ADDENDUM NO. 1

MIDWESTERN STATE UNIVERSITY
MOFFETT LIBRARY RENOVATION
PHASE I

Addendum Date: 2 April 2018

D-101

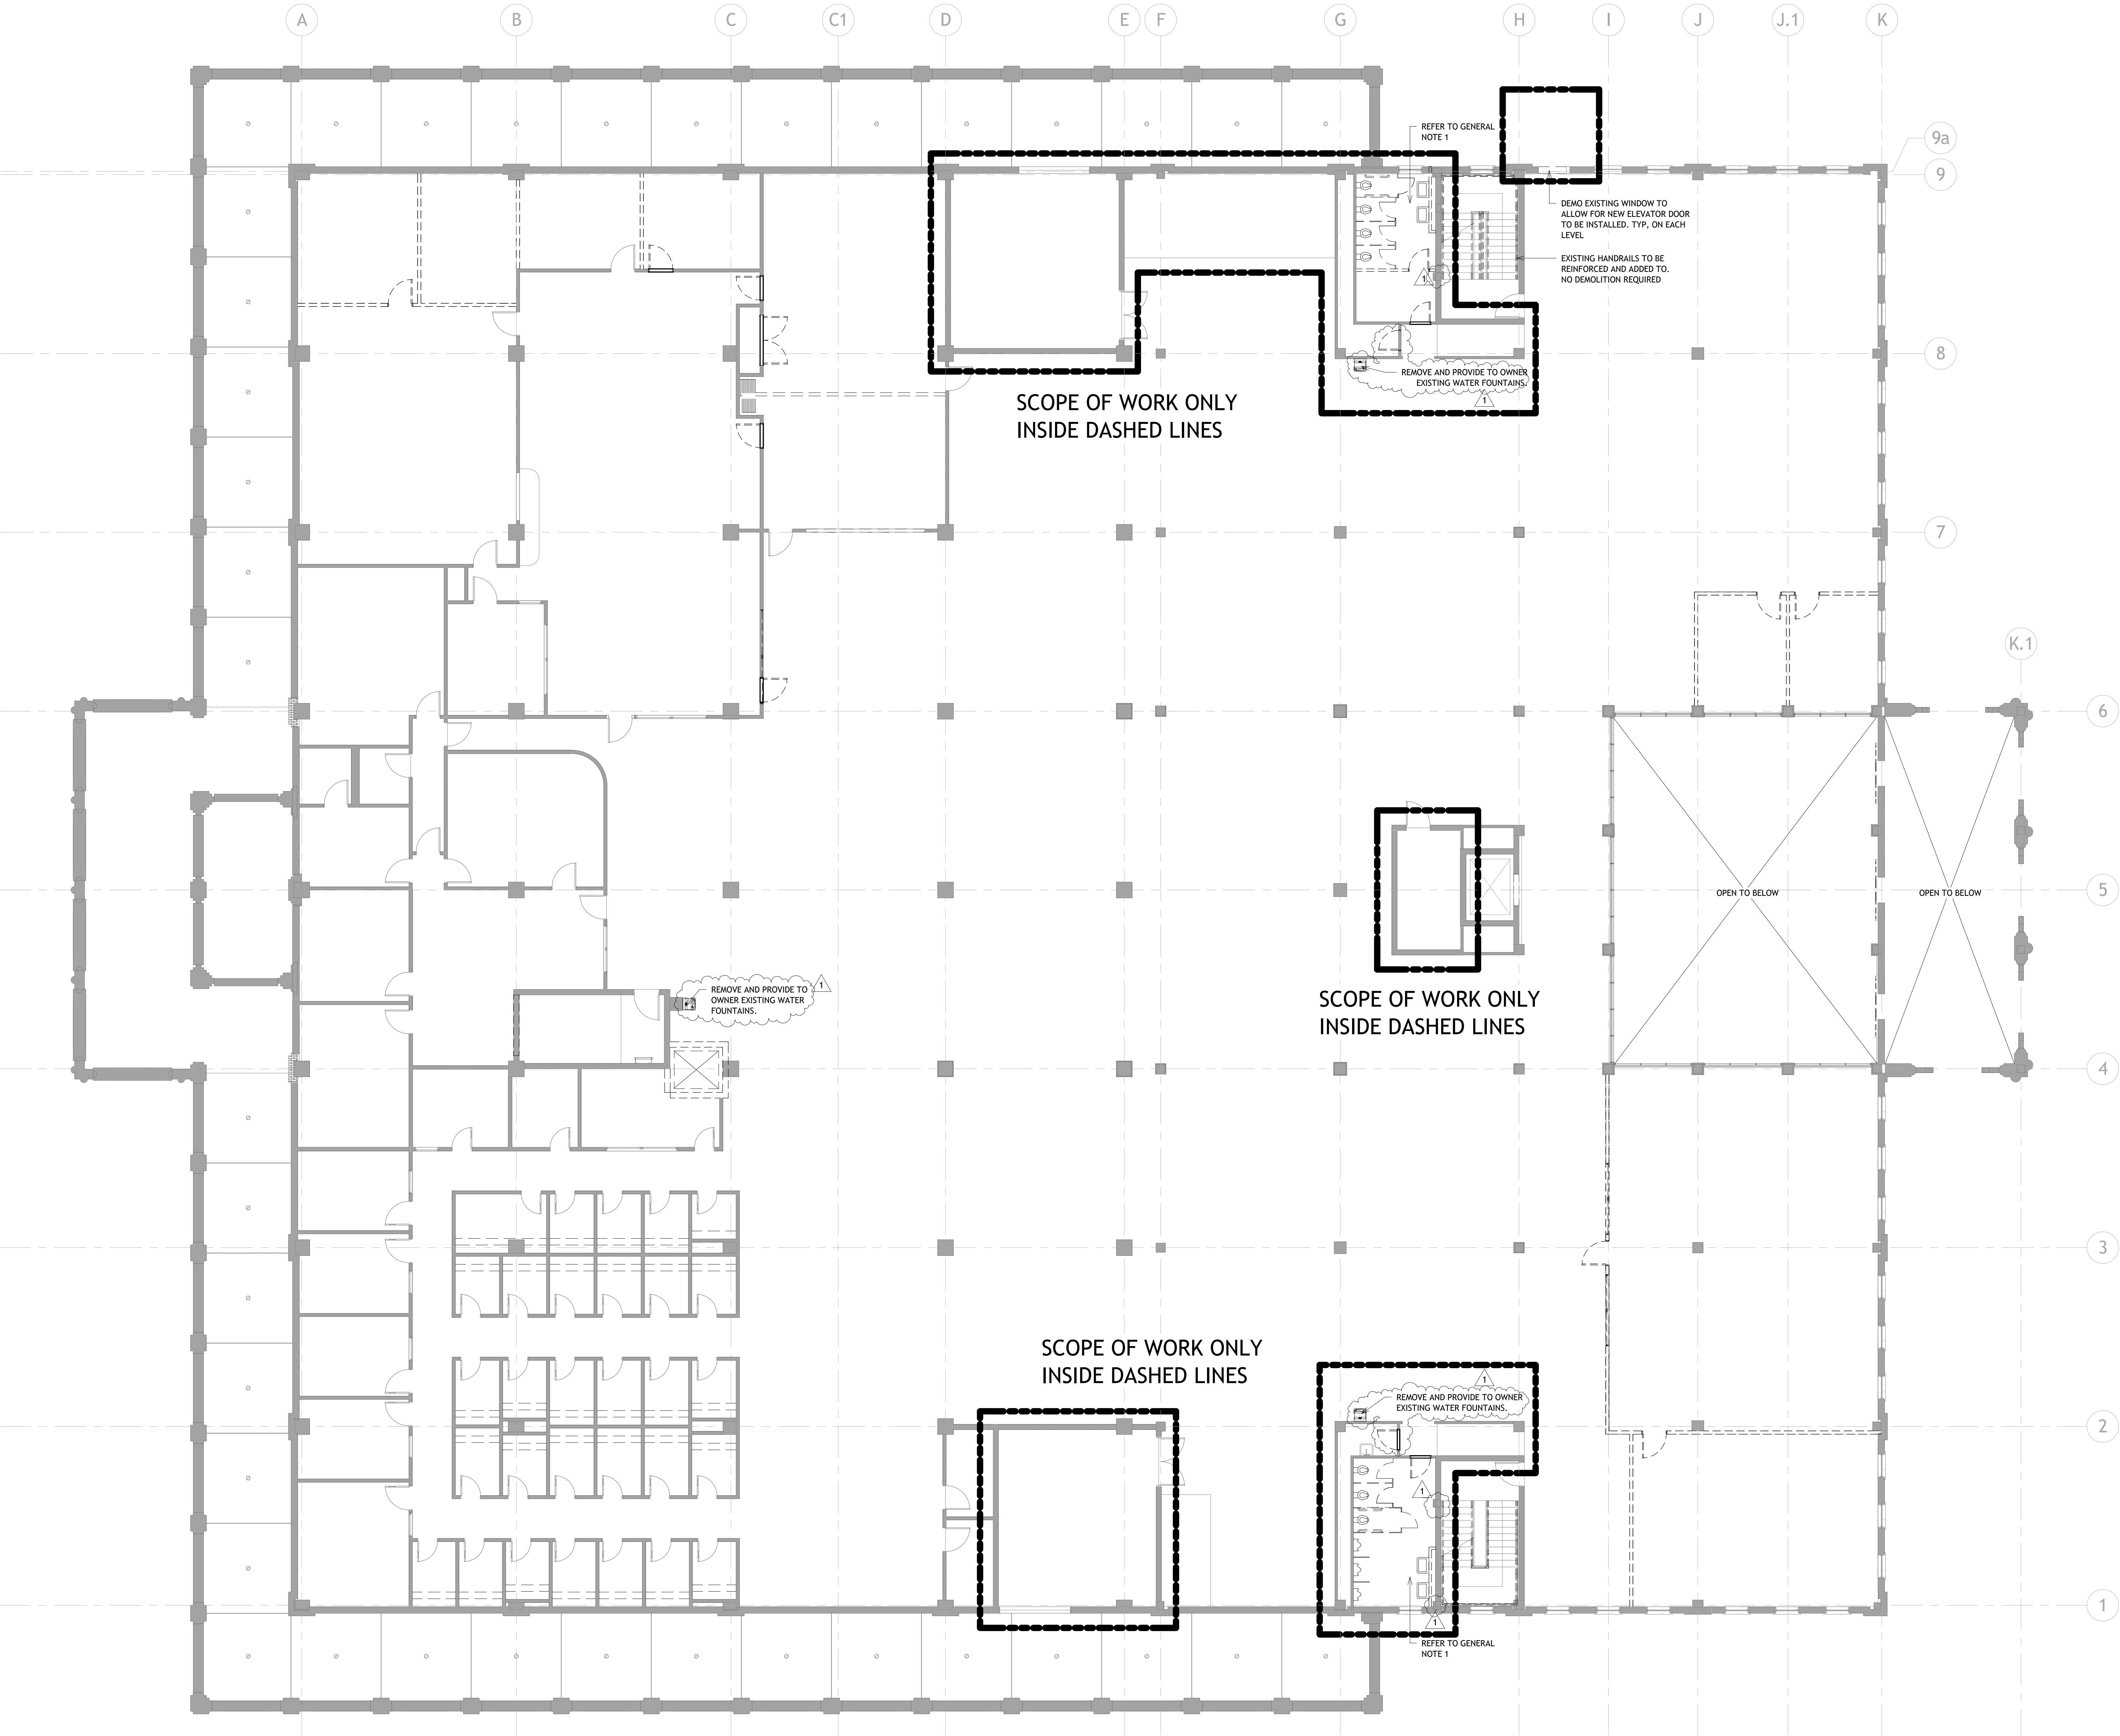
Replace the Drawings with the revised Sheets attached in this Addendum. Existing Electric Water Cooler (EWC) units are being removed with new bi-level EWC units being installed in specified locations. In addition, existing Doors/Frames #1CUST1, #1CUST2, #2CUST5, #2CUST6, #3CUST1, and #3CUST6 are being removed and new Door/Frames are being provided. Also, additional existing columns that are

A-101

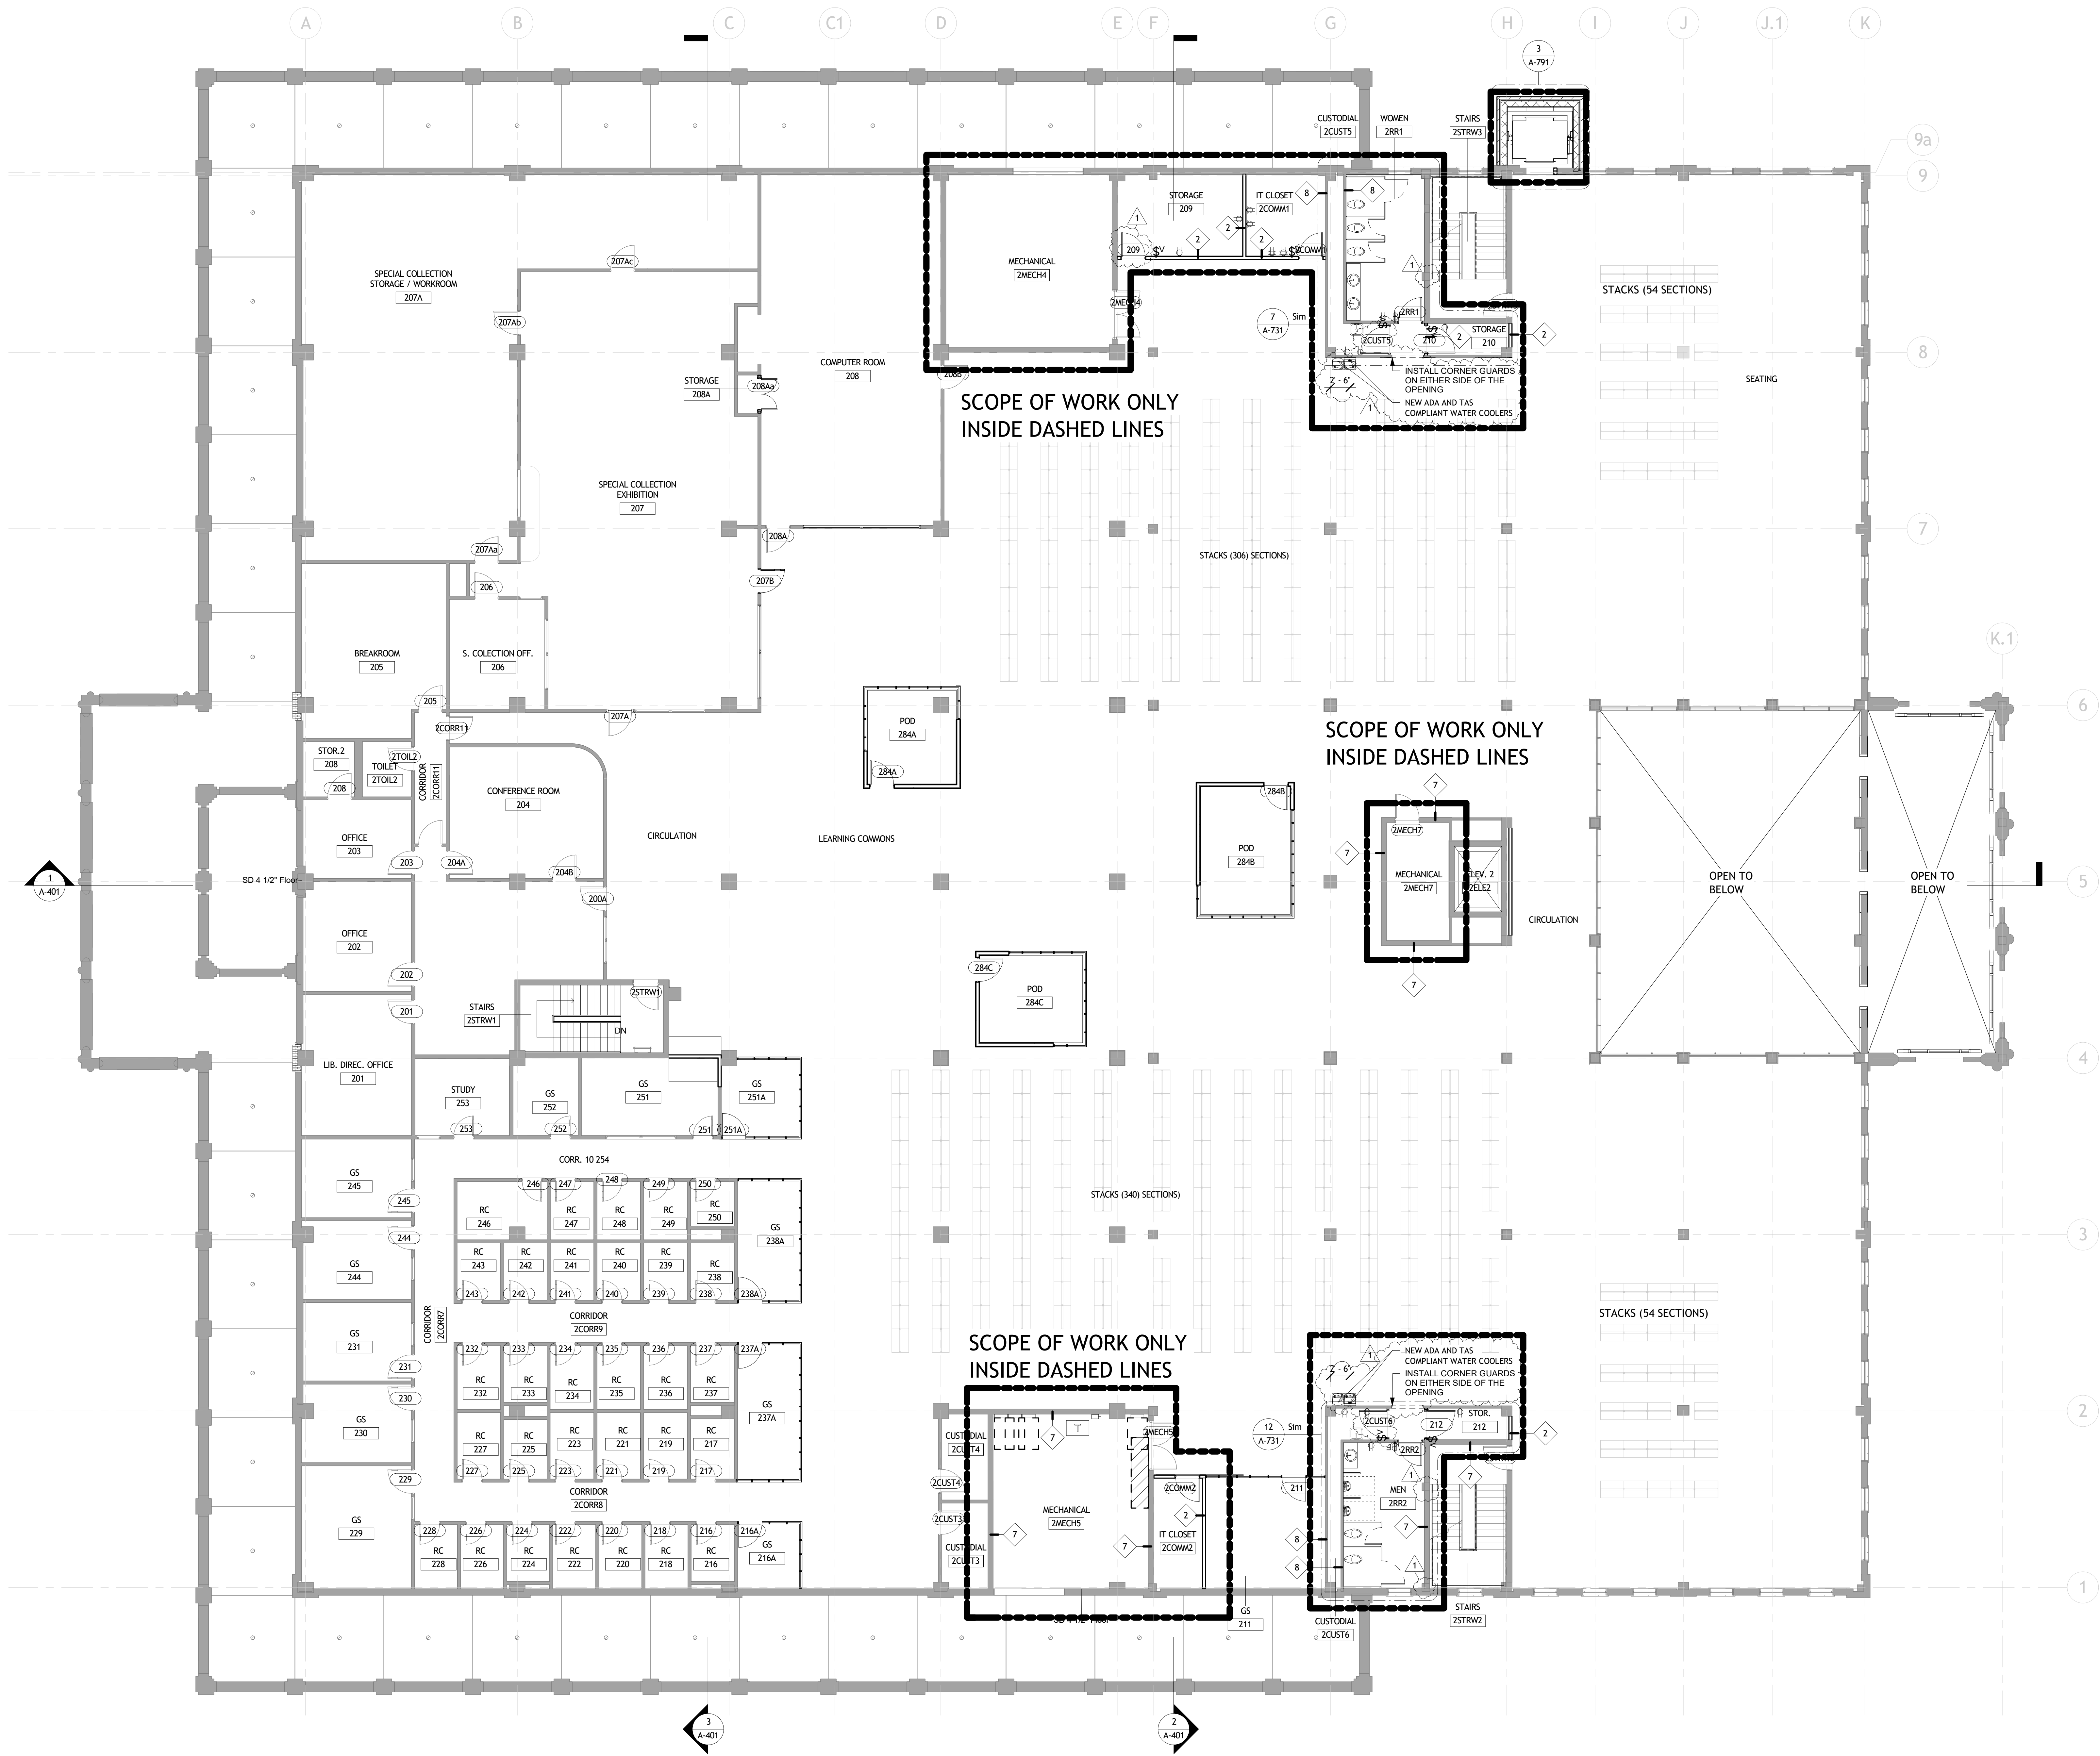
located in the spaces have been depicted in the Plans. Locations of wall corner guards have been added. Refer to Items "II(C)" above and "II(F)" & "II(G)" below for more information.
